FOV Pump CMB Evaluation Result

List of Evaluation Results

(This is an English translation of the evaluation results submitted to FJK's customers (NTC1-10221(2)), with comments in red added for FOV.)

FOV Pump CMB Evaluation Result

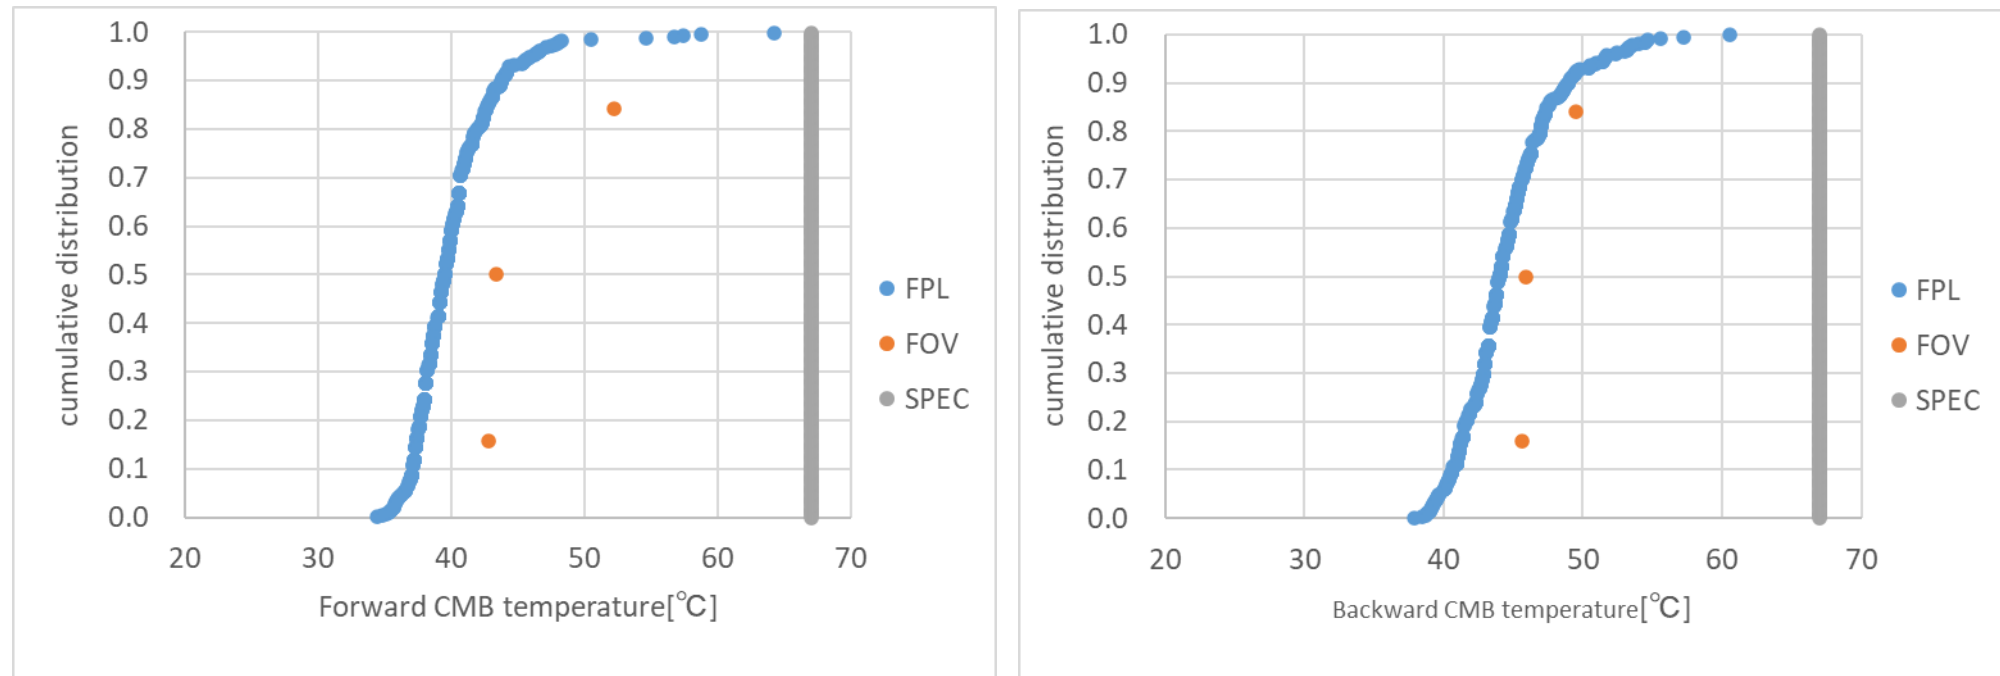
We have confirmed that there are no problems in all evaluation items as described above.

Please start mass production at FOV.
